SUBJECT: STAFF RESPONSE TO WILLIAM H. WARD'S LETTER ON
SEISMIC ISSUES AT WOLF CREEK

STAFF RESPONSE TO WILLIAM H. WARD'S LETTER ON
SEISMIC ISSUES AT WOLF CREEK

SUBJECT: SITE SPECIFIC GROUND RESPONSE SPECTRA FOR SEP PLANTS
LOCATED IN THE EASTERN UNITED STATES

Figure 6

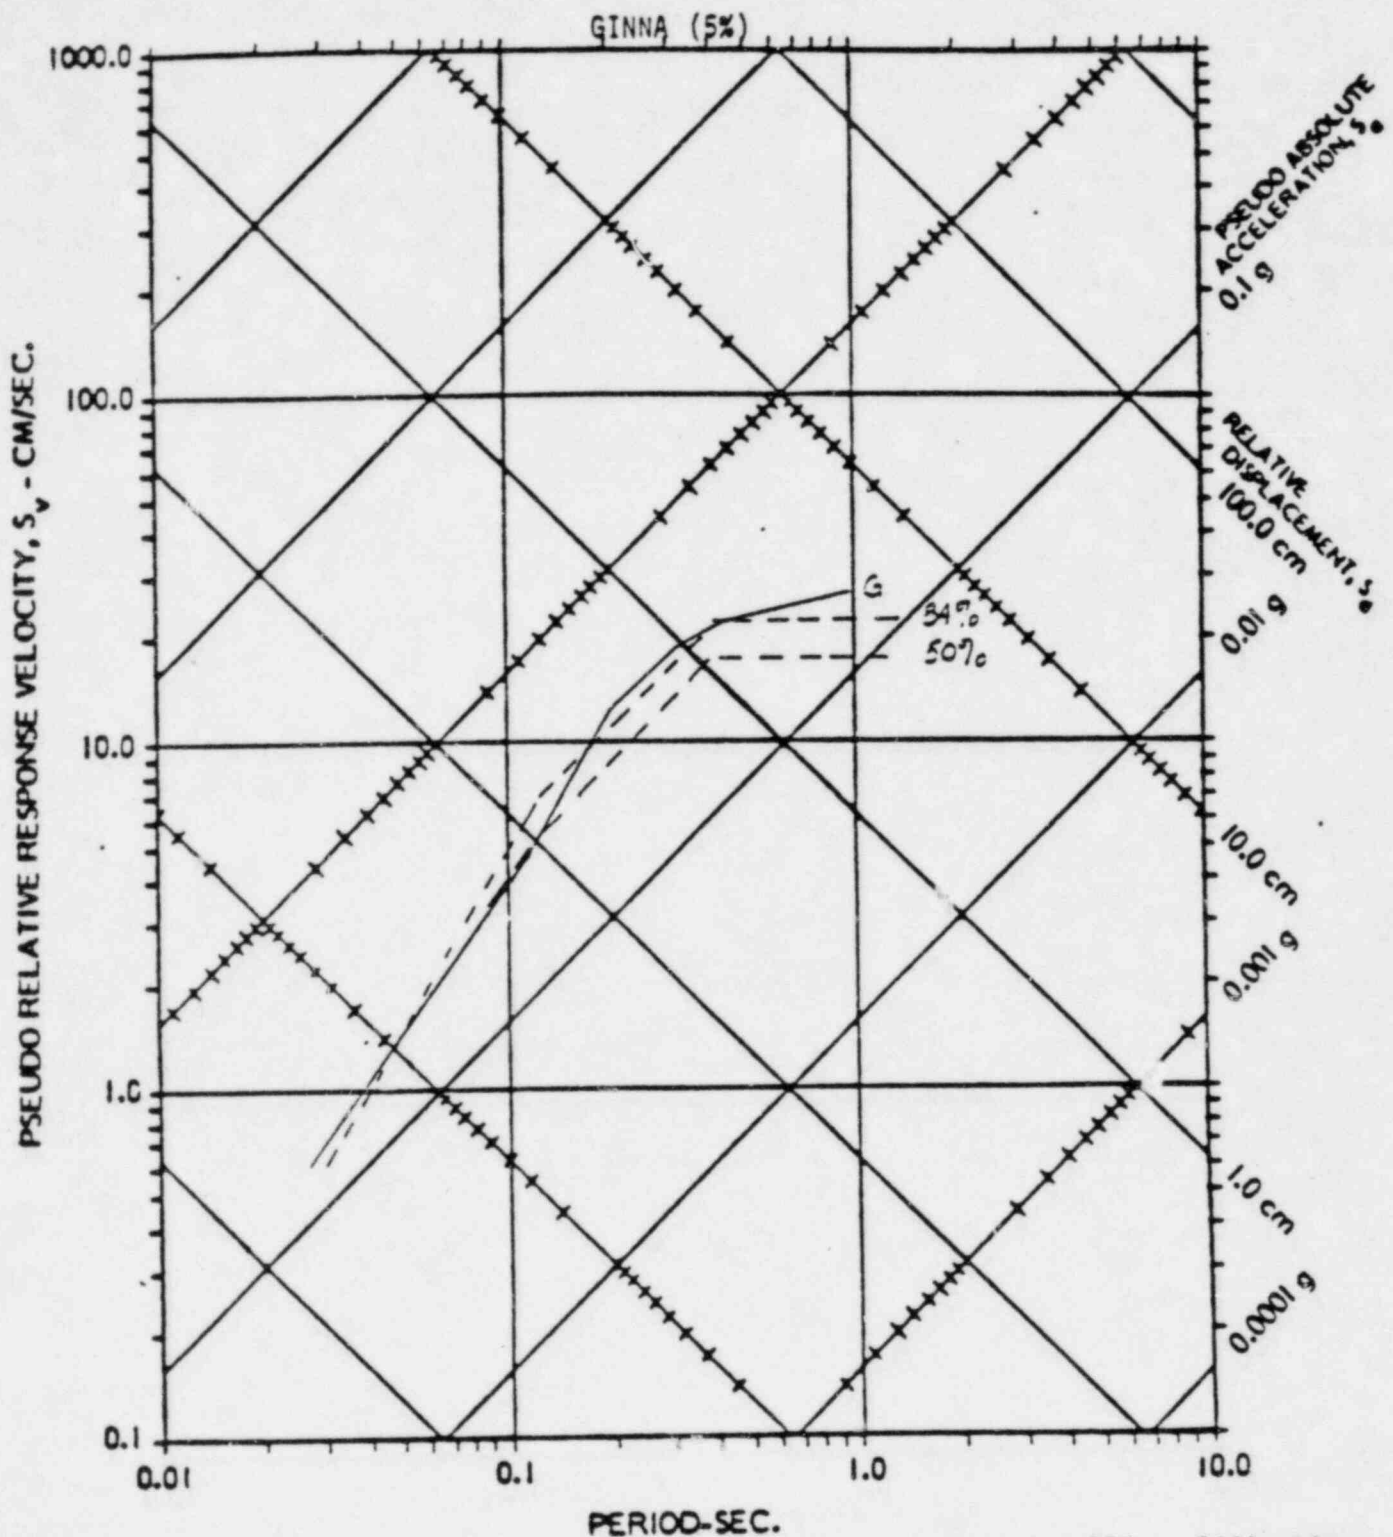
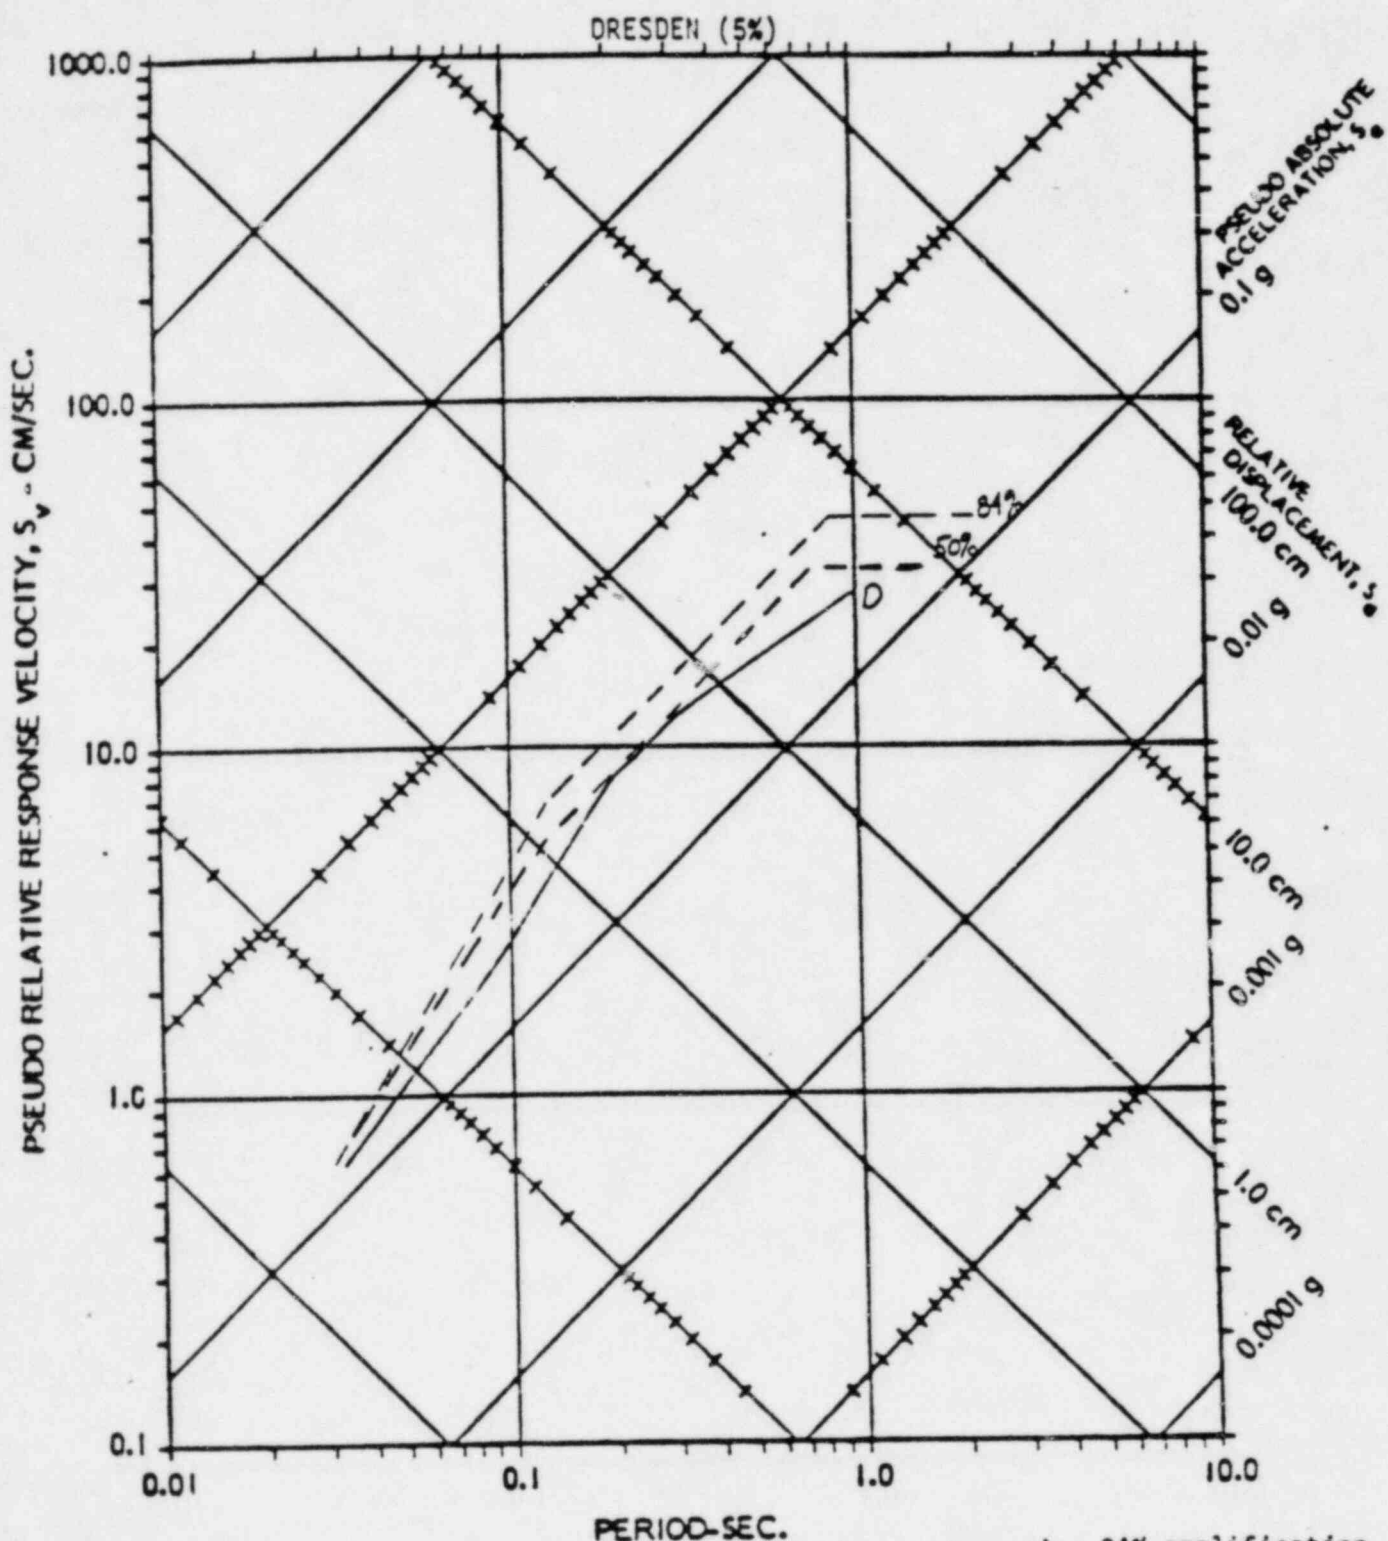
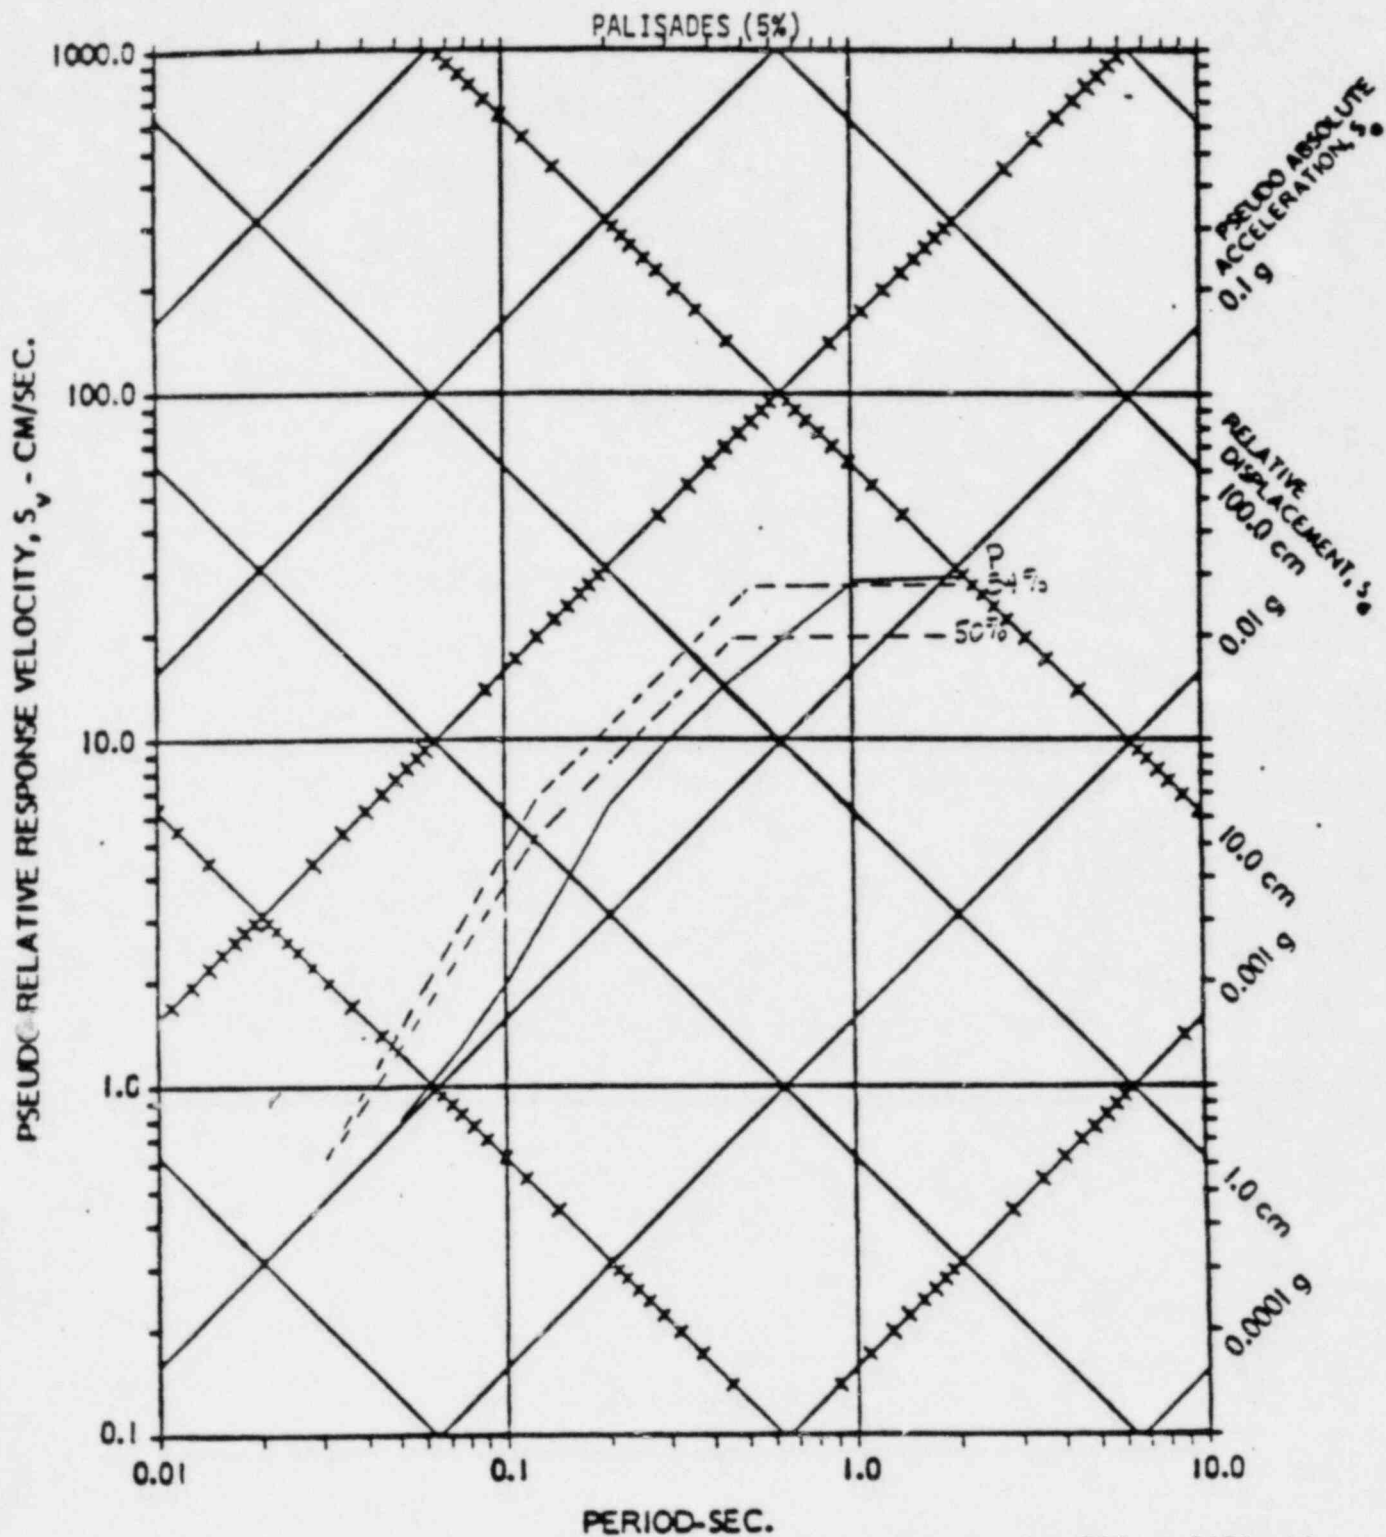
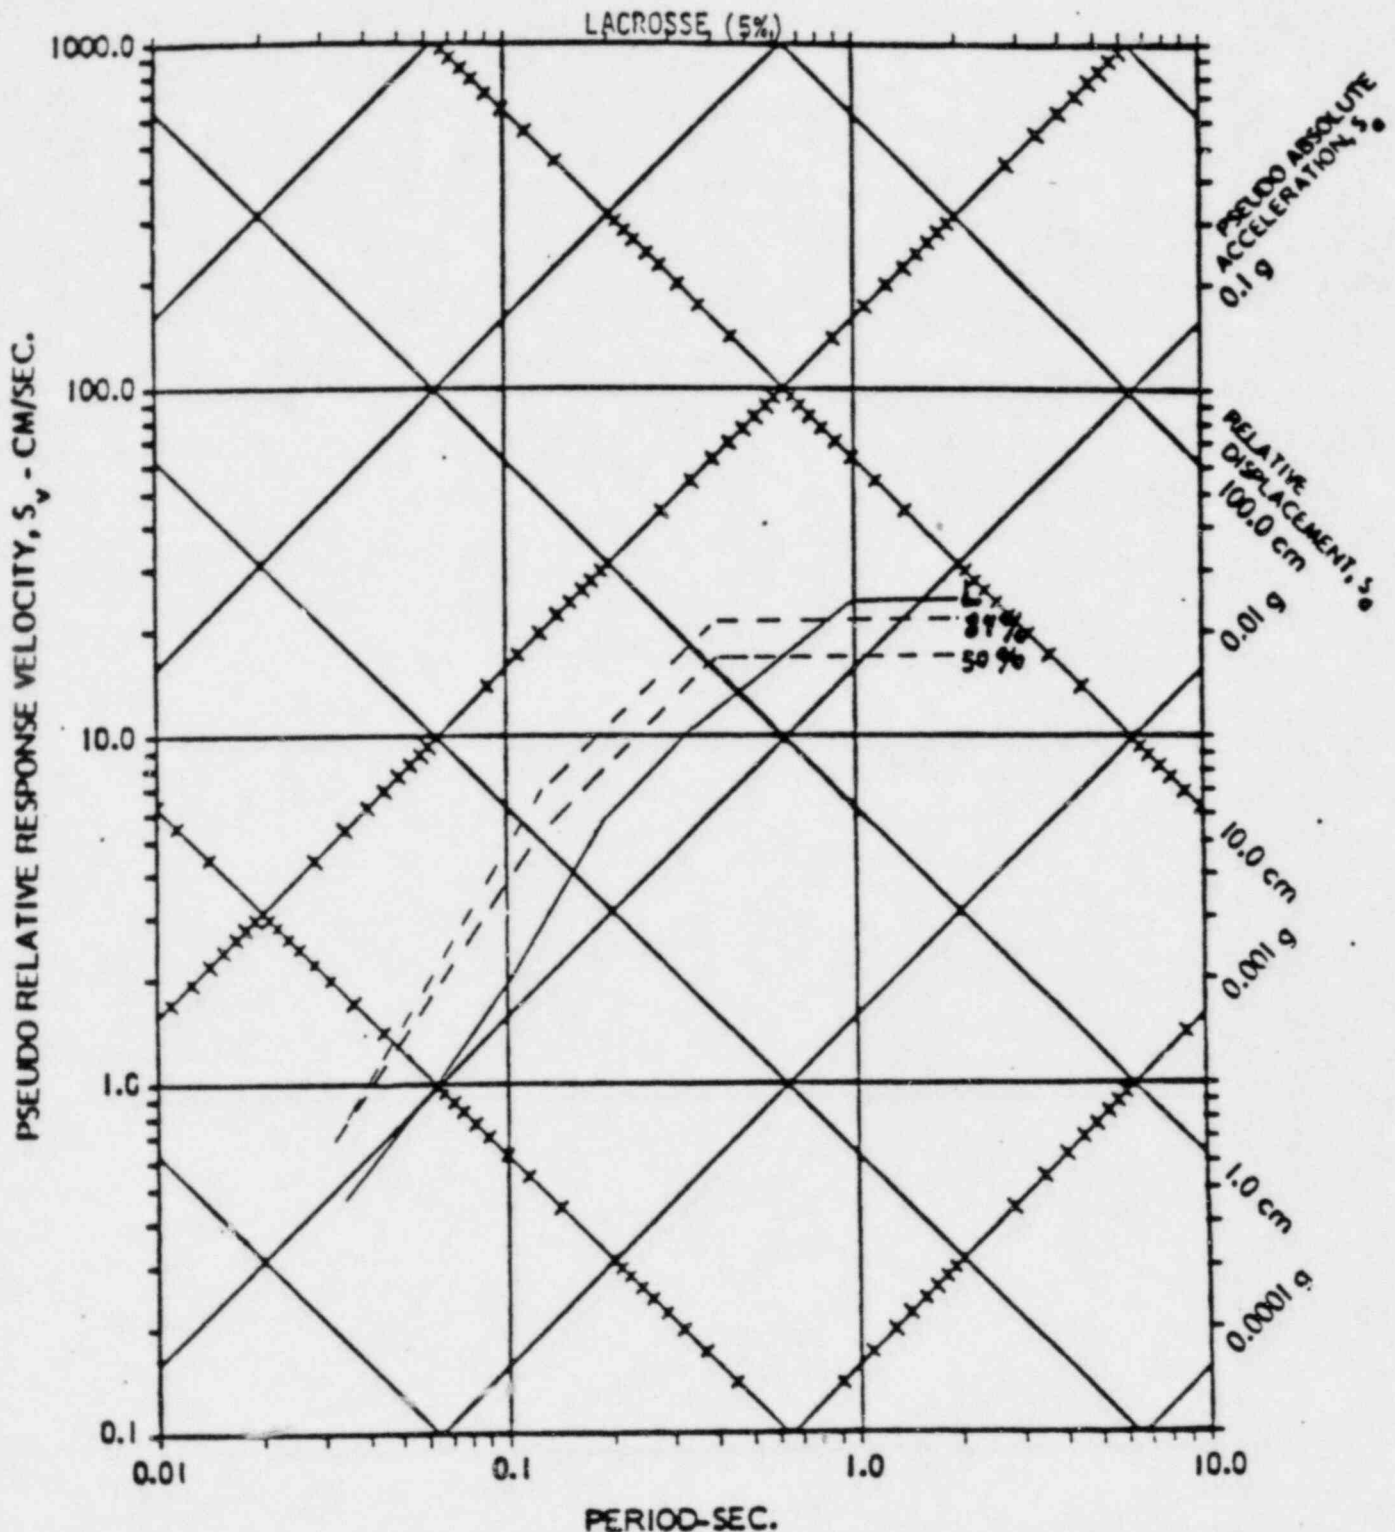
The deterministic peak accelerations and velocities are converted to response spectra using the amplification factors suggested by Newmark and Hall in NUREG CR-0098. Figs. 3 thru 11 compare the recommended uniform hazard spectra with 50th and 84th percentile deterministic spectra. In the central U.S. the recommended spectra generally fall below or at the 50th percentile. In the eastern United States the uniform hazard spectra are approximately

equivalent to the 84th percentile deterministic spectra. While the deterministic peaks are generally lower than the predicted peaks, use of the 84th percentile amplification factors usually more than compensate for the differences. Again the uniform hazard spectra more adequately reflect perceived relative hazard. The "tectonic province" approach can be made to achieve conservatism in this case by utilizing conservative amplification factors. Figures 12 and 13 show the uniform spectra compared to Reg. Guide 1.60 spectra anchored at 0.1 and 0.2g. Following suggested Standard Review Plan procedures for new plants that is utilizing the trend of the means of Trifunac and Brady (1975) to anchor the Reg. Guide 1.60 spectra, would result in design spectra anchored at between 0.12 and 0.20g. The specific acceleration used would depend in large part upon the applicants submittal and the reviewer's conservatism. For the central U. S. the recommended spectra are mostly below the Reg. Guide spectrum anchored at 0.1g while for eastern U. S. the recommended spectra are at or above the Reg. Guide spectrum anchored at 0.1g. The average recommended spectrum would be roughly equivalent to the Reg. Guide 1.60 Spectrum anchored at a peak acceleration of about 0.1g. The observation that the average peak acceleration associated with the recommended spectra (Table 2) is about 0.15g illustrates the often discussed conservatism of the Reg. Guide spectrum. It was conservatively derived from earthquakes of different sizes recorded at different distances and different site conditions.
